TECHNICAL EVALUATION REPORT (TER) REVIEW OF BAW-2148P,  
REV. 1, "LOW UPPER-SHELF TOUGHNESS FRACTURE ANALYSIS OF REACTOR  
VESSELS OF ZION UNITS 1 AND 2 FOR LOAD LEVEL A & B CONDITIONS"  
DOCKET NOS. 50-295 AND 50-304

J. G. Merkle and D. K. M. Shum

Oak Ridge National Laboratory  
Oak Ridge, Tennessee 37831

December 7, 1993

FIGURE 6

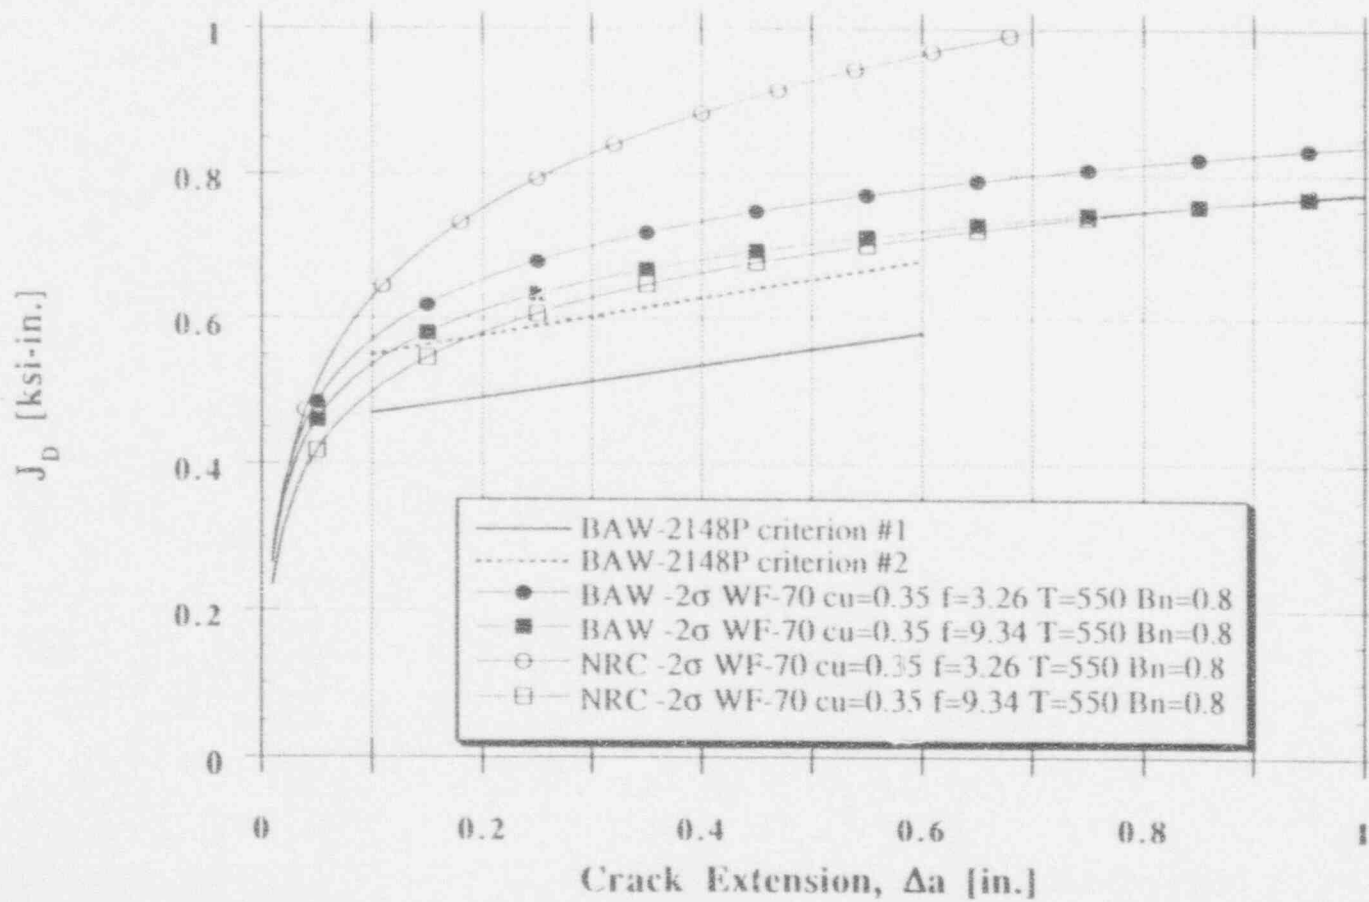
Calculated J-R curves for the Zion vessels, based on both the Eason-NRC and the Eason B&W correlations, and the applied J-R curves from Ref. 1 lead to the results shown in Figs. 6 and 7. For the copper content of WF-70 stated in Ref. 1, 0.35%, Fig. 6 shows, somewhat unexpectedly, that at a quarter-thickness fluence of  $3.26 \times 10^{18}$  n/cm<sup>2</sup>, the NRC correlation estimates a considerably higher J-R curve than the B&W correlation. But for a quarter-thickness fluence of  $9.34 \times 10^{18}$  n/cm<sup>2</sup>, the two curves are very close, with the NRC curve being slightly lower. Both criteria #1 and #2 for Level A and B are satisfied. For the copper content of Atypical weld metal, 0.41%, and quarter-thickness fluence of  $3.26 \times 10^{18}$  n/cm<sup>2</sup>, Fig. 7 shows that the J-R curve estimated by the B&W correlation is considerably lower than that estimated by the NRC correlation and that both Criteria #1 and #2 are satisfied. Furthermore, the lowest (B&W) curve in Fig. 7 for % Cu = 0.41 and  $f = 3.26$  nearly coincides with the two lowest (B&W and NRC) curves in Fig. 6 for % Cu = 0.35 and  $f = 9.34$ . Thus the B&W correlation appears to provide considerably better compensation for the possible presence of Atypical weld metal and variability of copper content in WF-70, for Level A and B loads, than the NRC correlation. However, Fig. 8 shows that this comparison depends on fluence. The B&W correlation predicts a steeper initial decline in tearing resistance with increasing fluence than the NRC correlation for % Cu = 0.35. However, a reversal occurs near the peak quarter-thickness circumferential fluence in the Zion vessels, so that for fluences exceeding  $10^{19}$  n/cm<sup>2</sup>, the NRC correlation would be more conservative. Fig. 9 shows that at a fluence of  $10^{19}$  n/cm<sup>2</sup>, the NRC correlation is more conservative than the B&W correlation for  $0.26 < \% \text{ Cu} < 0.41$ . Thus the conservatism of the B&W correlation is somewhat specific to the quarter-thickness fluence range in the Zion vessels.

FIGURE 10

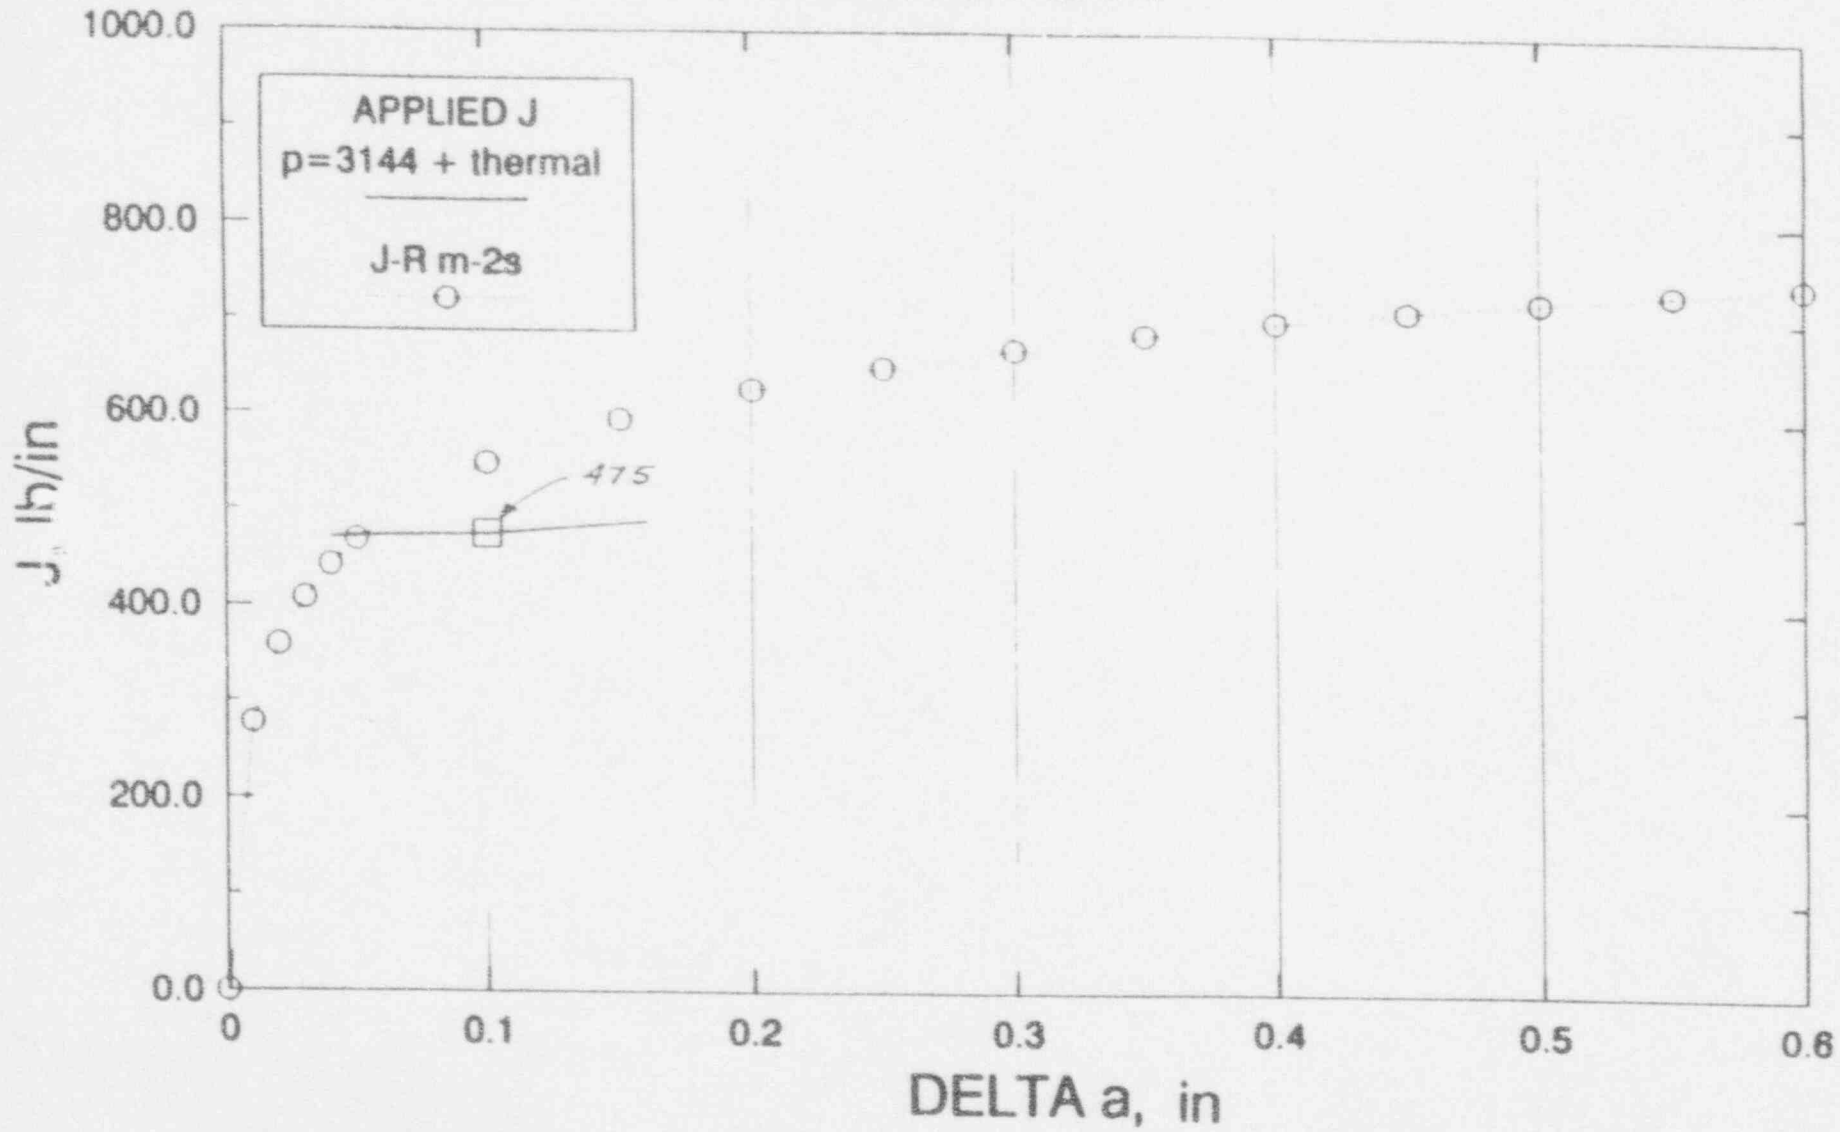
In examining Fig. 5-13 of Ref. 1, it appeared that the plotted point for J applied at  $\Delta a = 0.10$  in. for criterion #1 does not correspond to the state value of J - 487.5 in-lbs./in.<sup>2</sup> Scaling from an expanded copy of the figure, as shown in Fig. 10, the plotted point corresponds to J = 475 in-lbs./in.<sup>2</sup> thus making the margin look bigger than it is. Considering all the matters of accuracy discussed above, it was deemed prudent to perform some independent checking and sensitivity calculations for the Zion vessels.

FIGURE A1

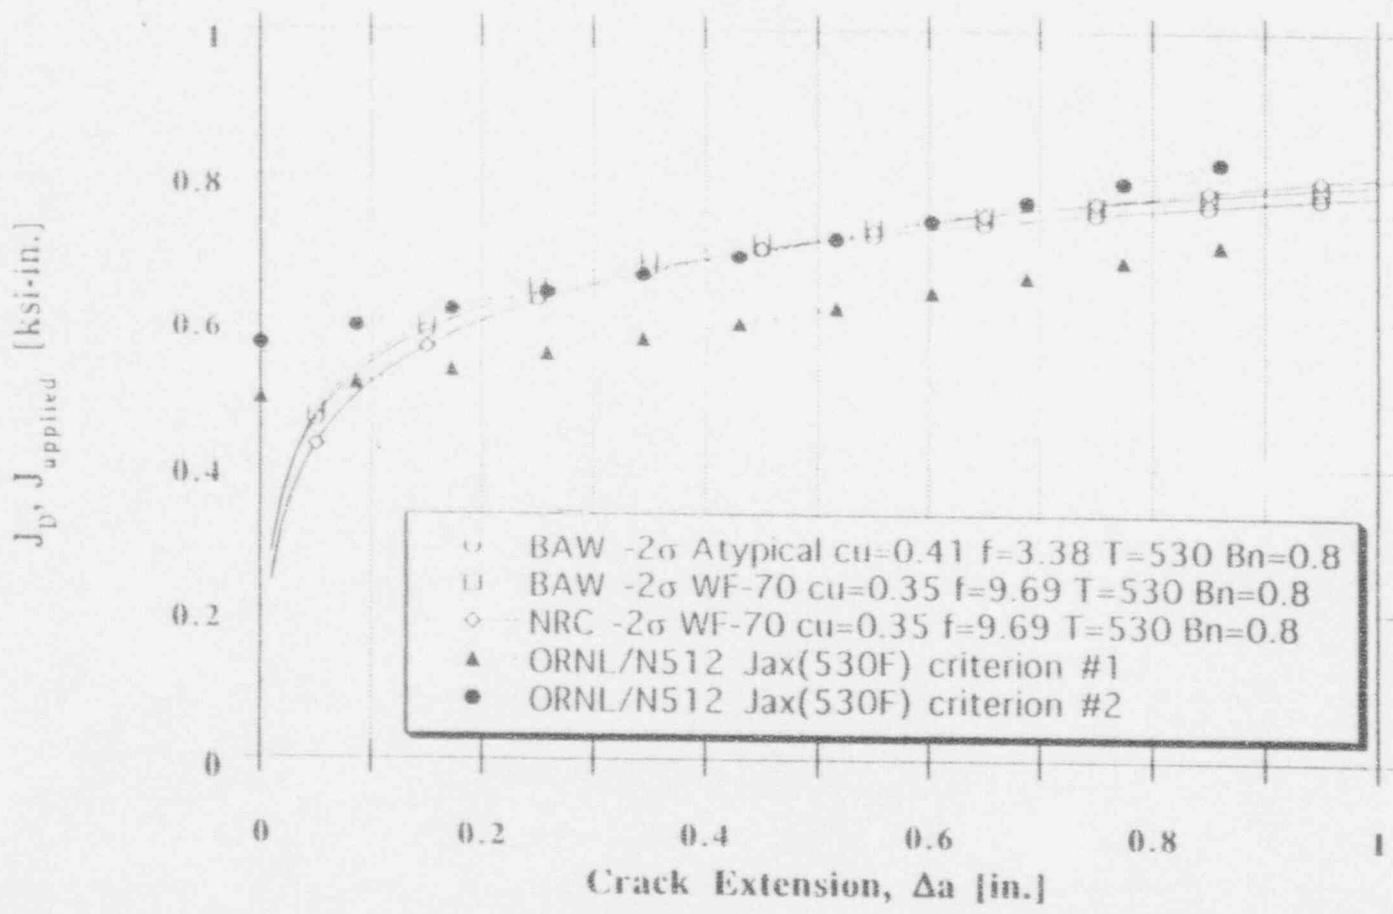
Fig. A1, which indicates the revised fluence values at  $t/4$  in the legend, shows that criterion #2, the stability criterion, is just satisfied for all three estimated  $-2\sigma$  J-R curves. For criterion #1, the limited crack growth criterion, the B&W correlation  $-2\sigma$  J-R curves both lie above the applied J curve at  $\Delta a = 0.10$  in. However, the NRC correlation  $-2\sigma$  J-R curve intersects the applied J curve just beyond  $\Delta a = 0.10$  in. The difference between the two values of J at exactly  $\Delta a = 0.10$  in. is extremely small, far less than the accuracy of the calculations. Considering in addition the fact that Ref. 16 recommends using a net section thickness of 1.0 in. with the NRC correlation instead of the more conservative value of 0.8 in. chosen in Ref. 1, criterion #1 is still considered satisfied, based on the NRC correlation, but with no excess margin. Based on the B&W correlation curves, a small amount of excess margin still exists.
